SUBMITTAL TO THE BOARD OF SUPERVISORS
COUNTY OF RIVERSIDE, STATE OF CALIFORNIA

SUBJECT: TRANSPORTATION AND LAND MANAGEMENT AGENCY/TRANSPORTATION: Approve Addenda to the Plans and Specifications, Accept the Low Bid and Award the Contract for the Construction of the Bridge Channel Revegetation for Replacement of Hamner Avenue Bridge Over Santa Ana River Project in the City of Norco. District 2. [$1,569,893 Total Cost – Federal Funds 88.5%, Local Funds 11.5%]

1. Approve six addenda to the plans and specifications issued prior to the June 4, 2025, bid opening;

The addenda were issued to clarify and make modifications to the approved contract documents. The addenda did not increase the engineer's cost estimate. The addenda are attached and designated as Addendum No. 1, 2, 3, 4, 5 and 6.

PREPARED BY	IRRIGATION NOTES AND DETAILS	SHEET No.
PREPARED UNDER THE SUPERVISION OF DICK ROL LANDSCAPE ARCHITECT 06/18/2024 DATE	BRIDGE CHANNEL REVEGETATION FOR REPLACEMENT OF HAMNER AVENUE BRIDGE	L3 SHEET 4 OF 12

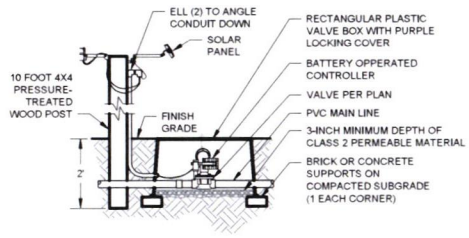
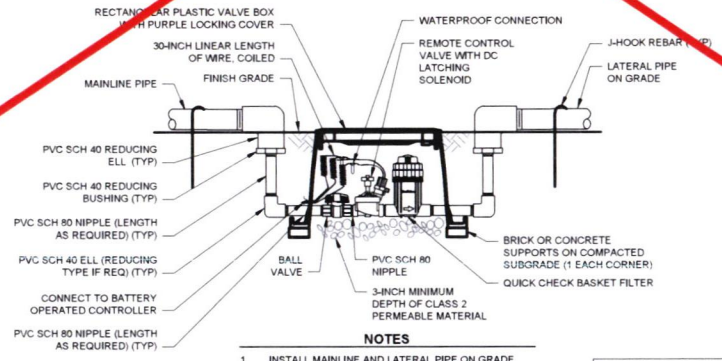
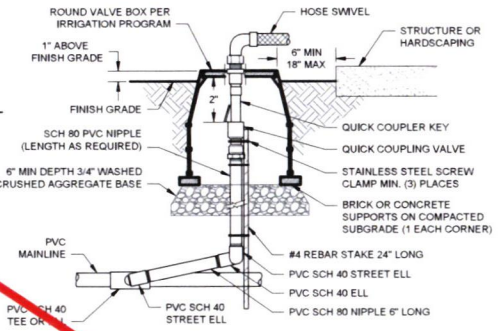
1. **Sheet L3, 4 of 12, Irrigation Notes and Details**
   Proposed work shown on Sheet L3 is removed from the project.
2. **Sheet L4, 5 of 12, Irrigation Details Continued**
   Proposed work shown on Sheet L4 is removed from the project.
3. **Sheet L5, 6 of 12, Irrigation Plans**
   Proposed work shown on Sheet L3 is removed from the project.
   (previously/inadvertently labeled as sheet 13 of 12)
4. **Sheet L6, 7 of 12, Irrigation Plans Continued**
   Proposed work shown on Sheet L4 is removed from the project.

SHEET REMOVED PER ADDENDUM No. 6

PREPARED BY	IRRIGATION DETAILS CONT.	SHEET No.
PREPARED UNDER THE SUPERVISION OF DICK ROL LANDSCAPE ARCHITECT 06/18/2024 DATE	BRIDGE CHANNEL REVEGETATION FOR REPLACEMENT OF HAMNER AVENUE BRIDGE	L4 SHEET 5 OF 12

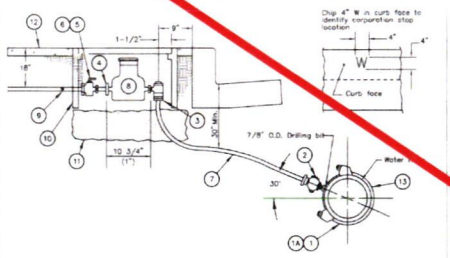
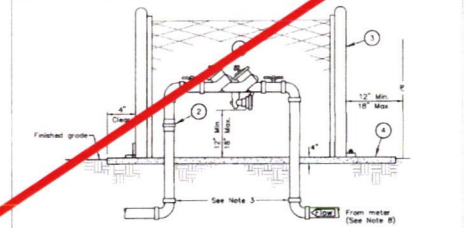
SHEET REMOVED PER ADDENDUM No. 6

PREPARED BY	IRRIGATION PLAN 5	SHEET No.
PREPARED UNDER THE SUPERVISION OF DICK RIOL LANDSCAPE ARCHITECT 06/18/2024 DATE	BRIDGE CHANNEL REVEGETATION FOR REPLACEMENT OF HAMNER AVENUE BRIDGE	L5 SHEET 13 OF 12

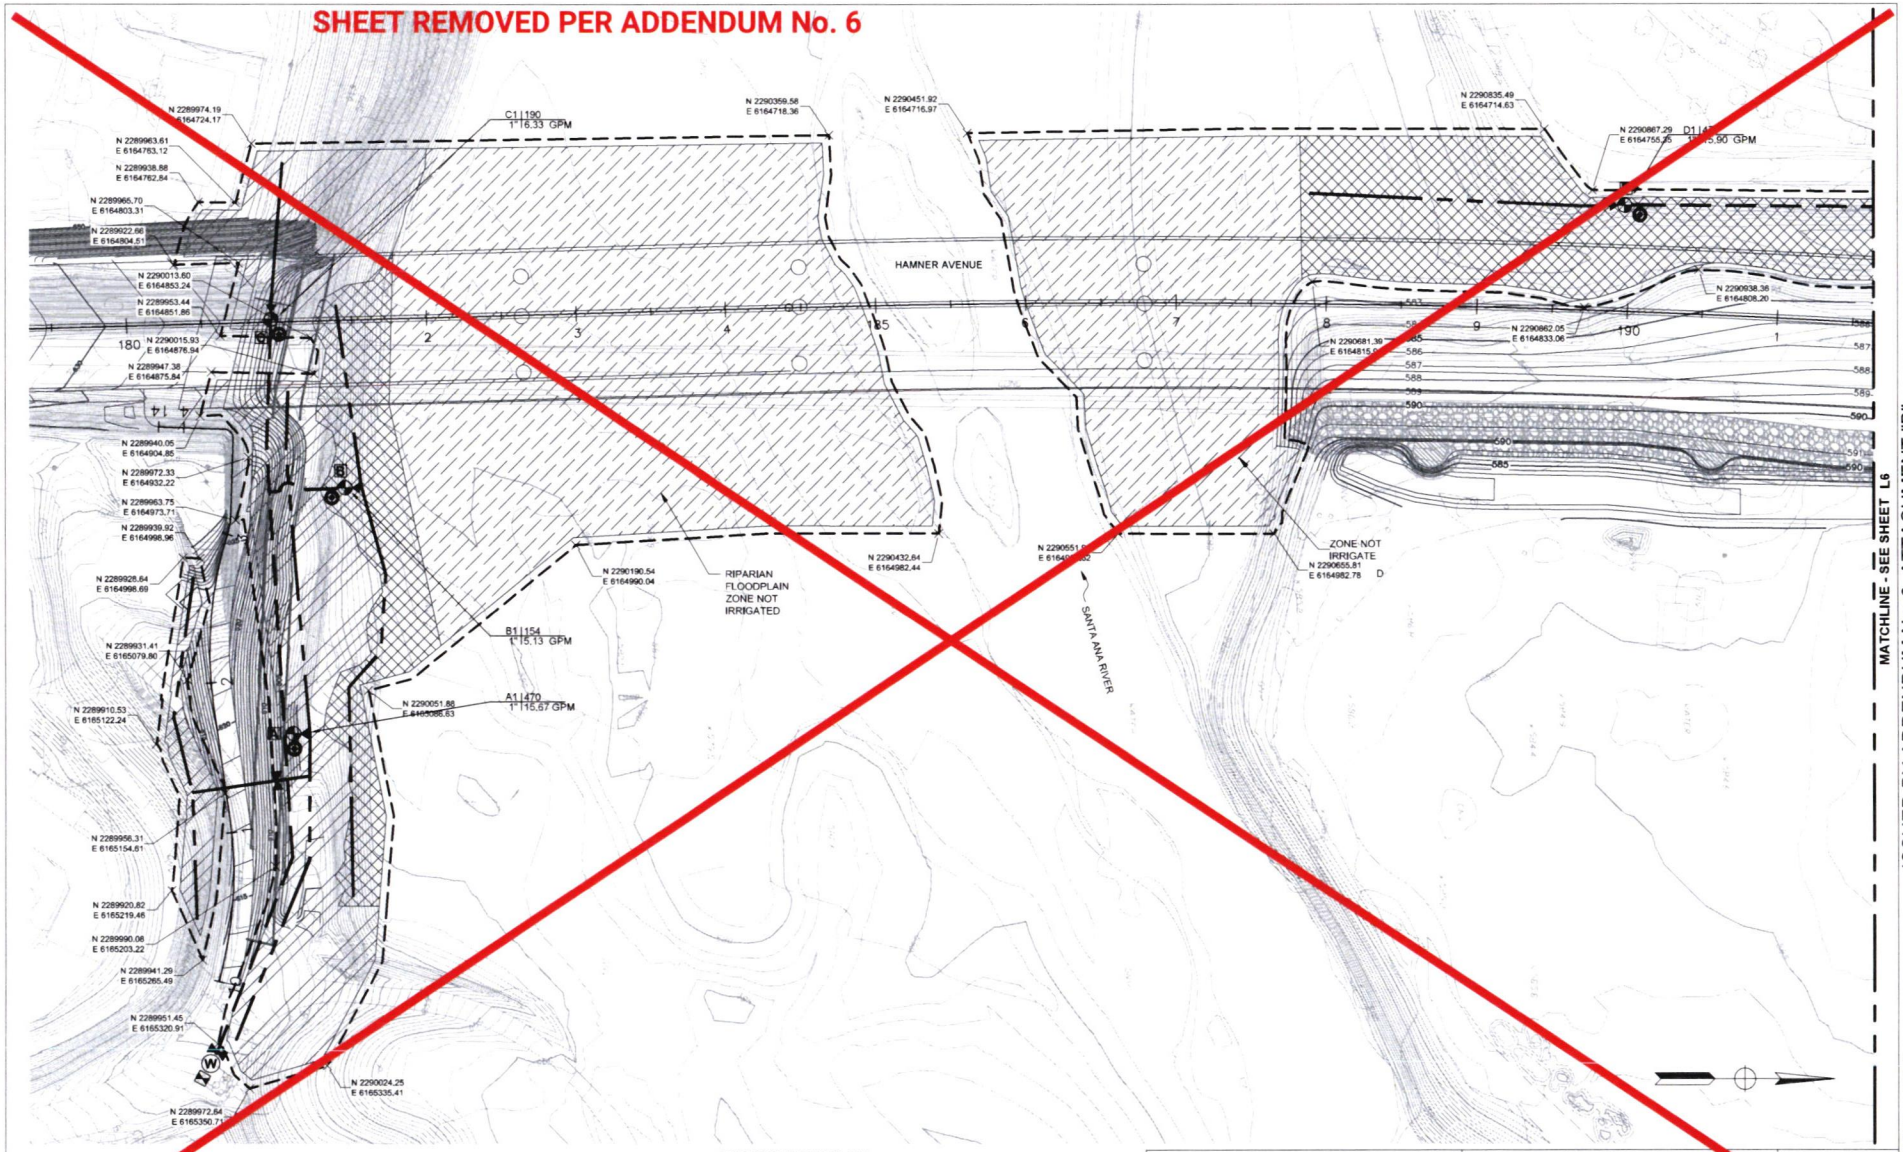
SHEET REMOVED PER ADDENDUM No. 6

PREPARED BY	IRRIGATION PLAN CONT.	SHEET No.
PREPARED UNDER THE SUPERVISION OF 06/18/2024 DATE DICK BOL LANDSCAPE ARCHITECT	BRIDGE CHANNEL REVEGETATION FOR REPLACEMENT OF HAMNER AVENUE BRIDGE	L6 SHEET 7 OF 12

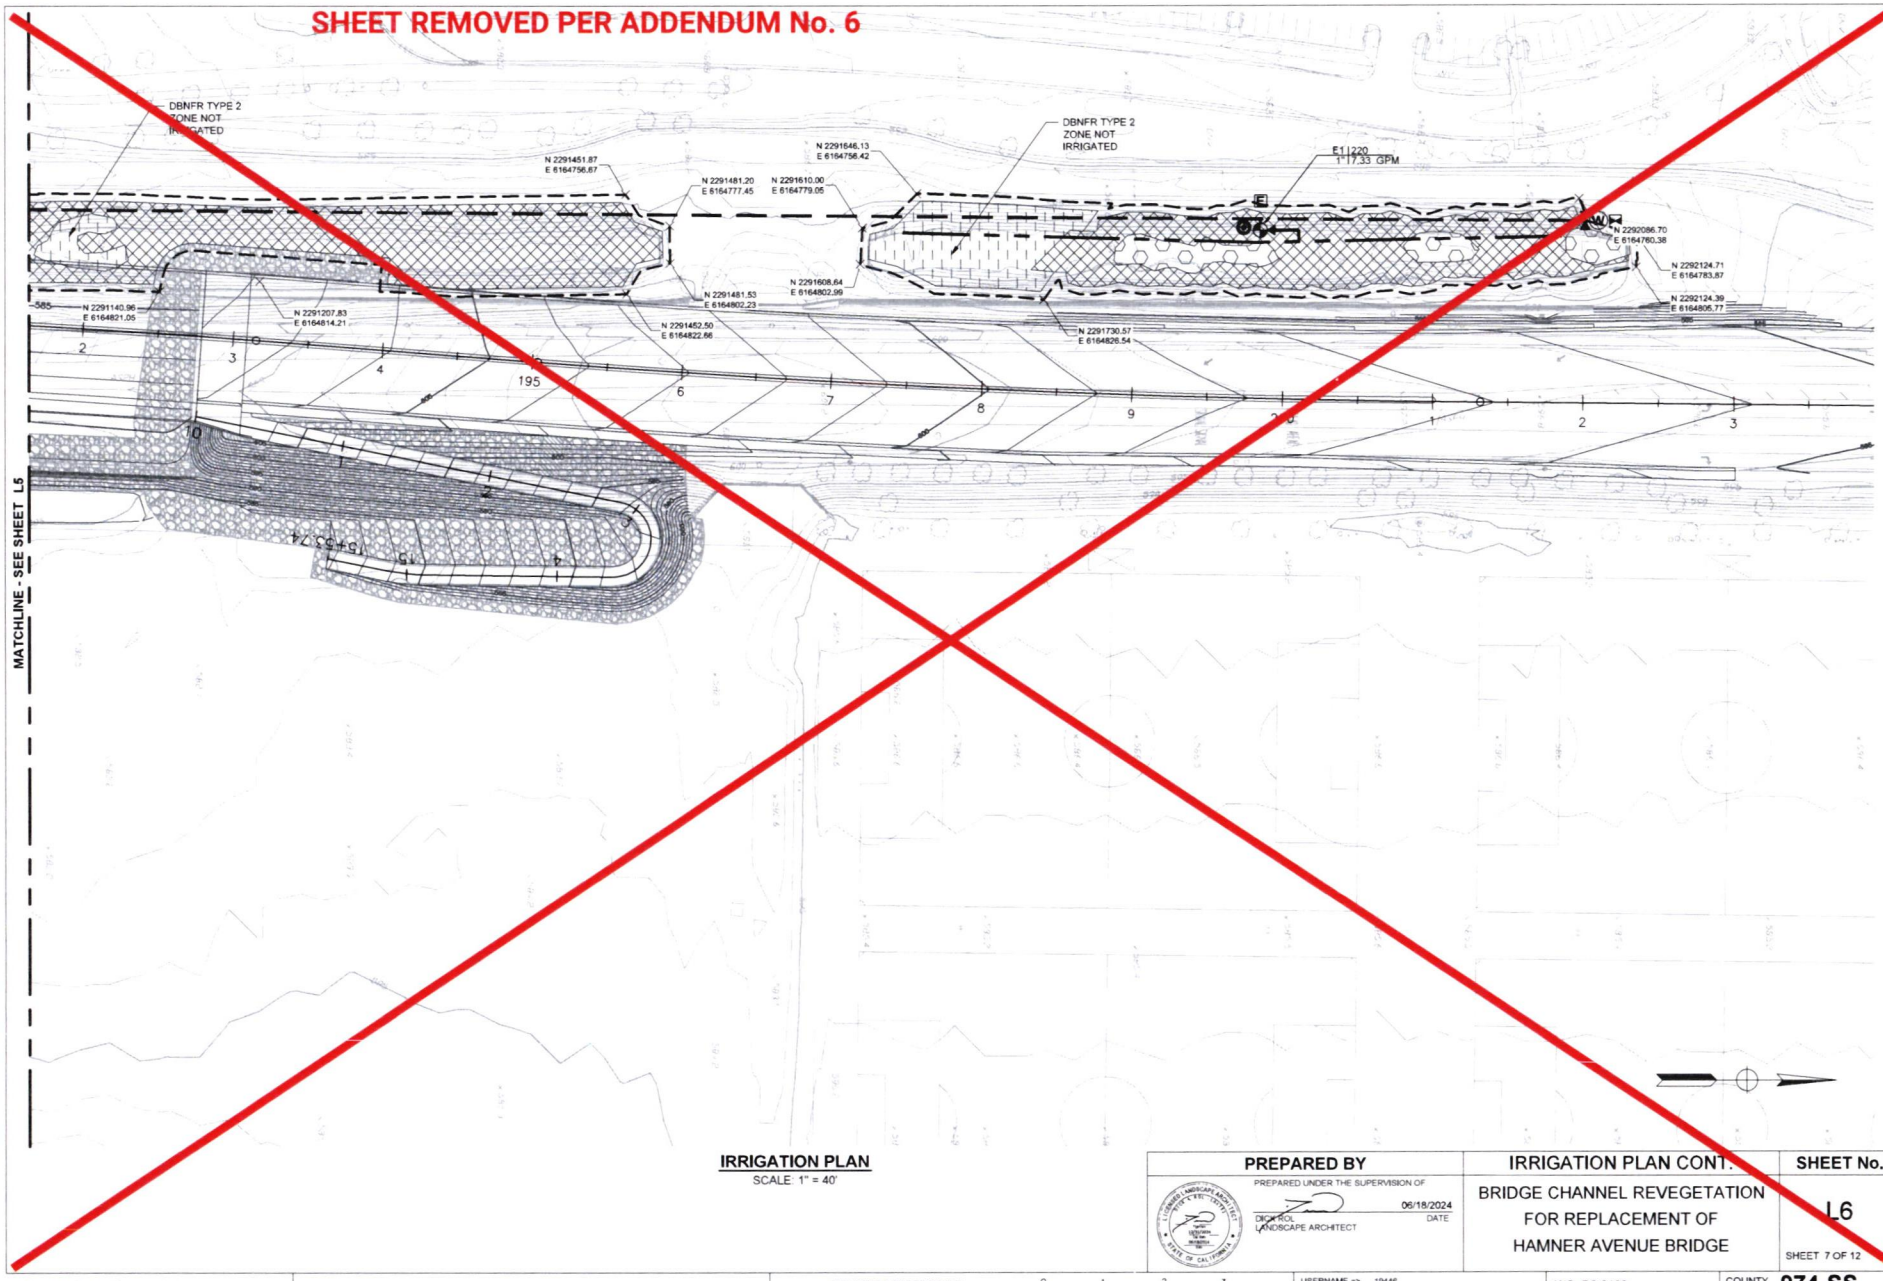
ISSUED BY ADDENDUM No. 6, ATTACHMENT "B"

PREPARED BY	DRAINAGE AND GRADING	SHEET No.
PREPARED UNDER THE SUPERVISION OF: PHILIP BRAND No. C75694 Exp. 06-30-2026 CIVIL STATE OF CALIFORNIA PHILIP BRAND 5/15/2025 PROJECT ENGINEER DATE TY LIN INTERNATIONAL	BRIDGE CHANNEL REVEGETATION FOR REPLACEMENT OF HAMNER AVENUE BRIDGE	C-1 SHEET 13 OF 13

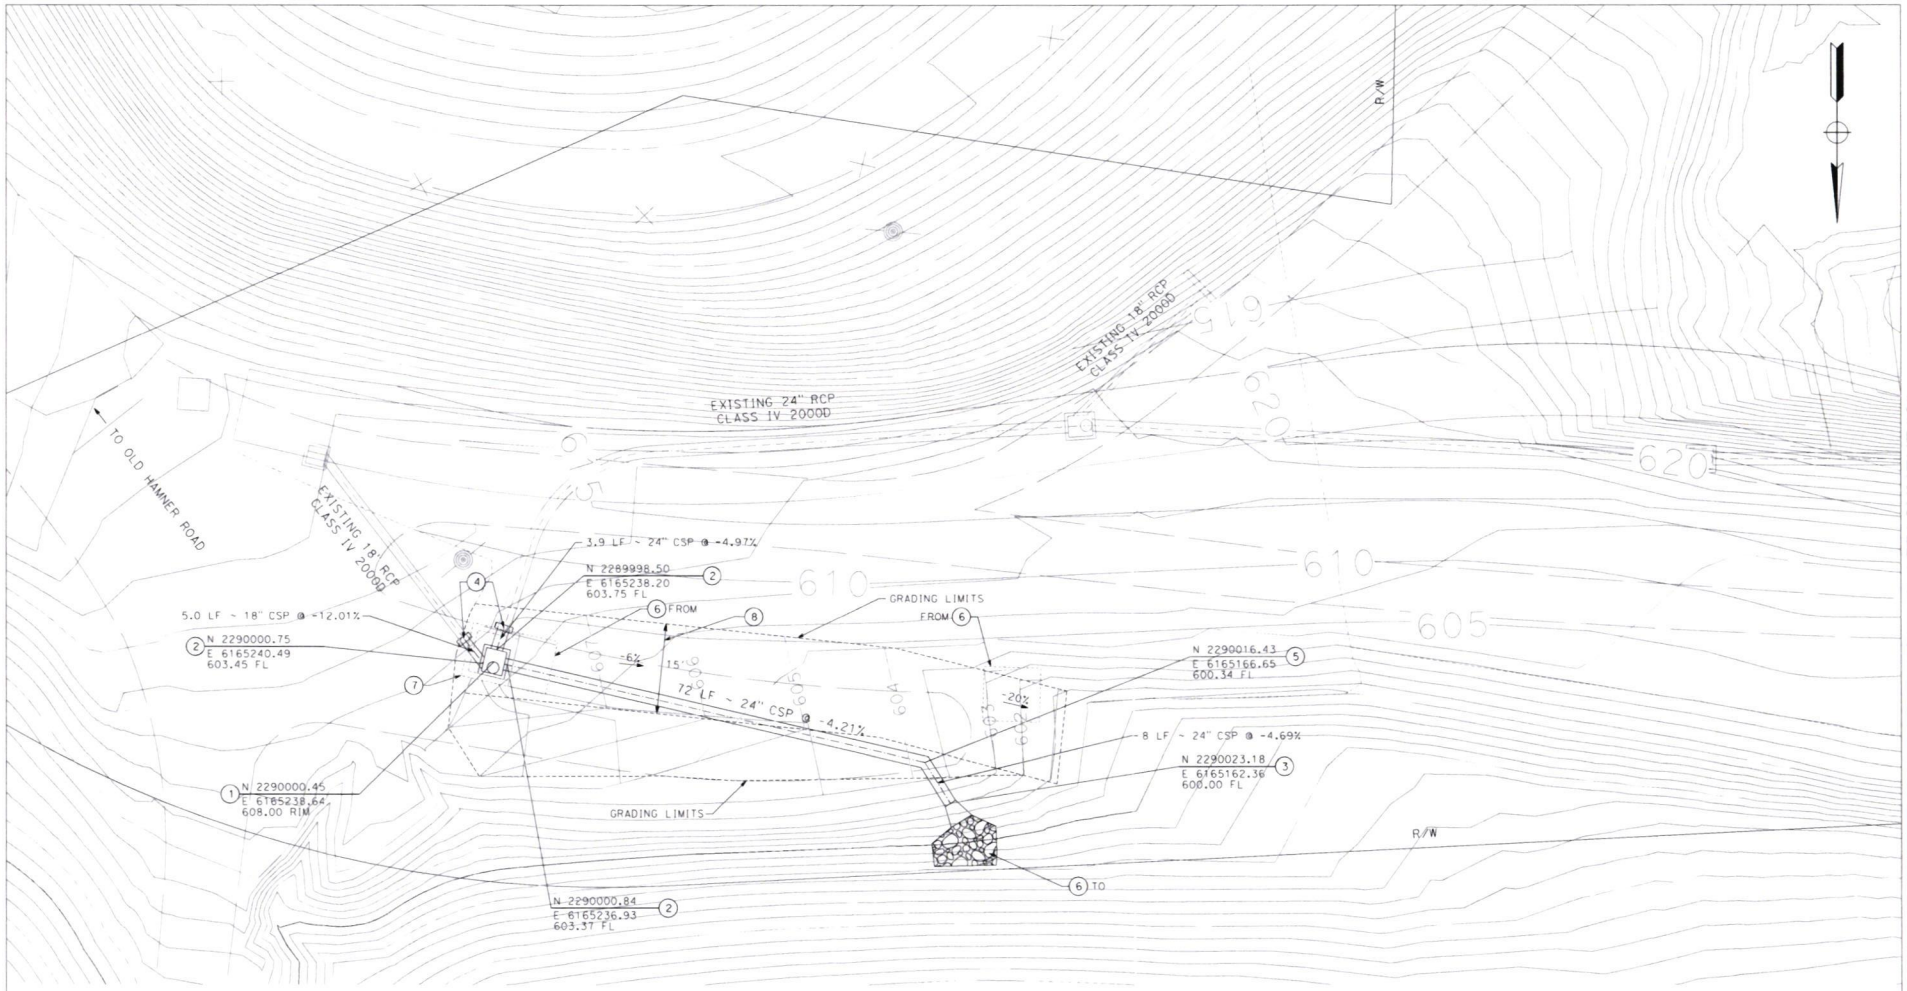
Drainage Facility Modification
The existing Drainage Facility located at the south side of the Hamner Avenue bridge approximately 400-feet east of Hamner Avenue shall be modified a shown on the Drainage and Grading plan SHEET No C-1, SHEET 13 of 13, that is incorporated hereby as **Attachment "C"**.
